Model Error Resolution Document <i>Complete only applicable items.</i>		QA: QA
			Page 1 of 2

1. Document Number:	MDL-WIS-PA-000005	2. Revision/Addendum:	Rev 00 and AD 01	3. ERD:	ERD 05
4. Title:	Total System Performance Assessment Model/Analysis for the License Application				
5. No. of Pages Attached:	24

This Error Resolution Document (ERD) is provided to update the *Total System Performance Assessment for the License Application* (TSPA-LA) documents, including Rev 00, the addendum (AD 01), ERD 02 and ERD 04, to correct issues identified in the following condition reports (CRs). The corrections identified are necessary to add clarity and strengthen the discussion within the suite of TSPA-LA documents. There are no impacts on results or conclusions due to the clarifications and text revisions from the CRs listed below. CR 12543, however, will have an impact on the results from the TSPA-LA localized corrosion initiation analysis (Appendix O), but will have no effect on the overall model conclusions that are based on the calculation of repository performance.

Figure B-1. Road Map of TSPA-LA Model Data Tracking Numbers

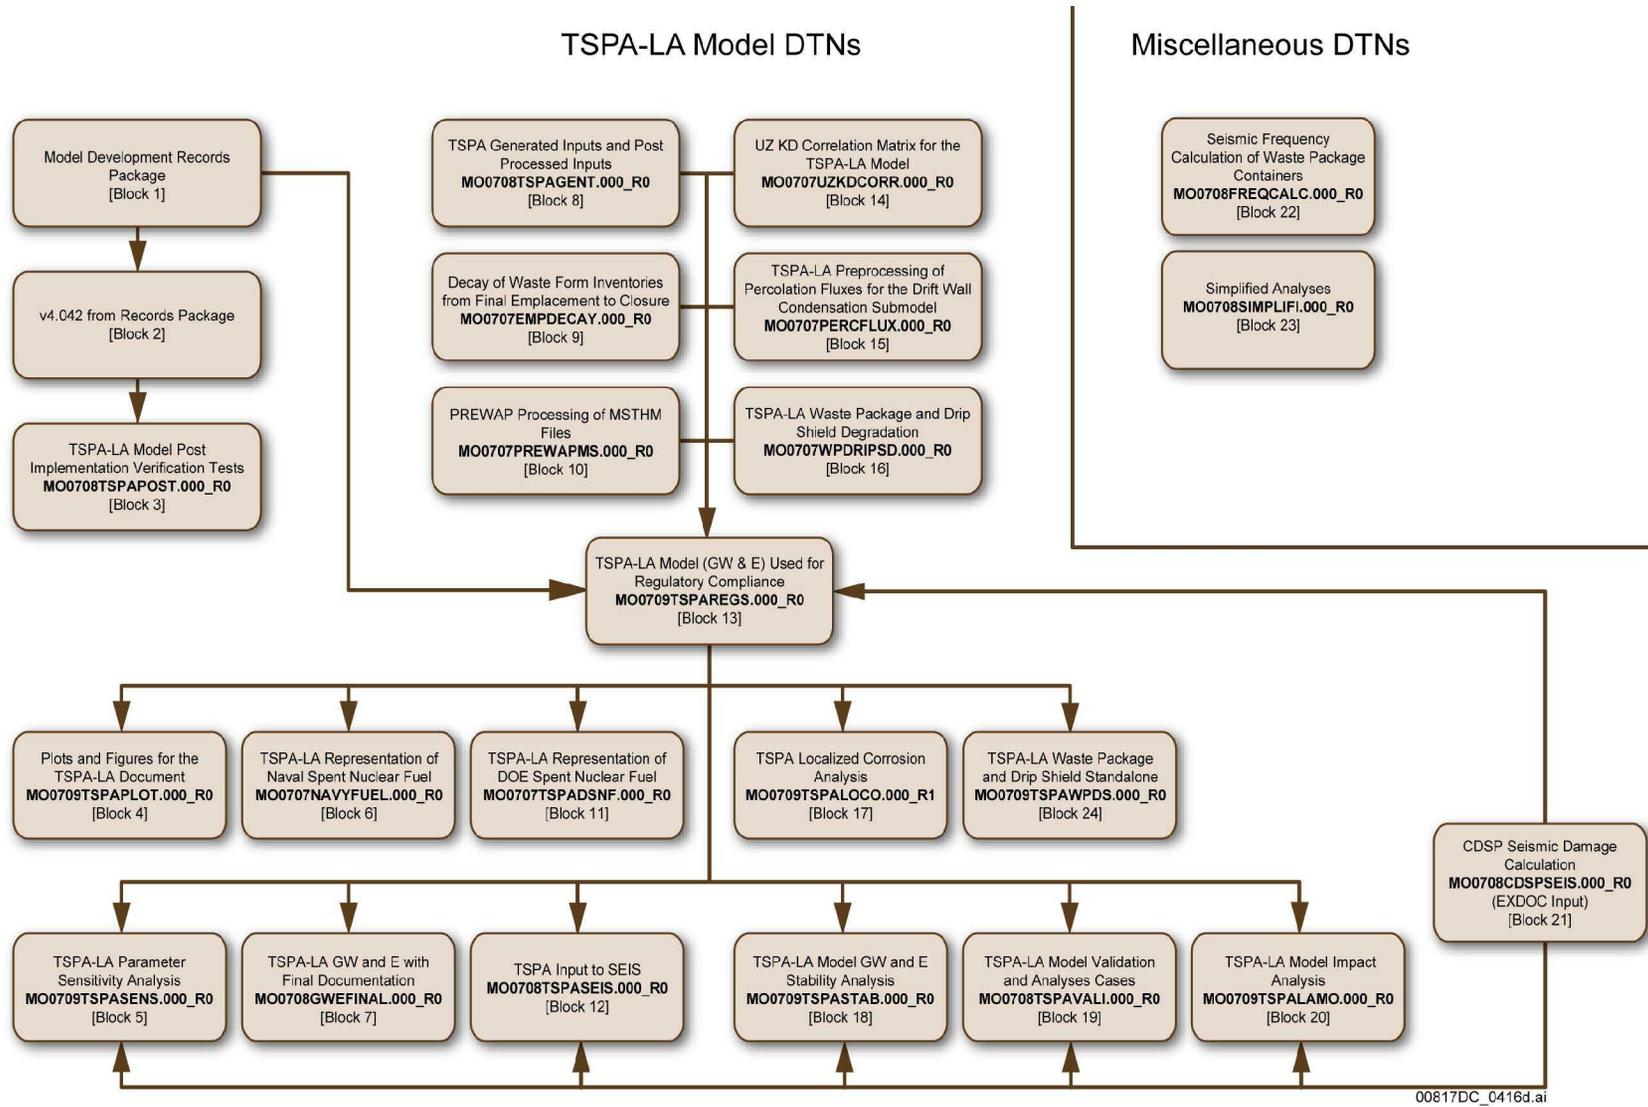
Replace Figure B-1 in order to revise the DTN reference in Block 17 (page B-9):

Reference Figure B-1, Block 17—This DTN contains the GoldSim runs that are used to confirm that localized corrosion is addressed by the Compliance Model that is documented in output DTNs MO0709TSPAREGS.000 [DIRS 182976] and MO0710TSPAWO.000 [DIRS 183752].
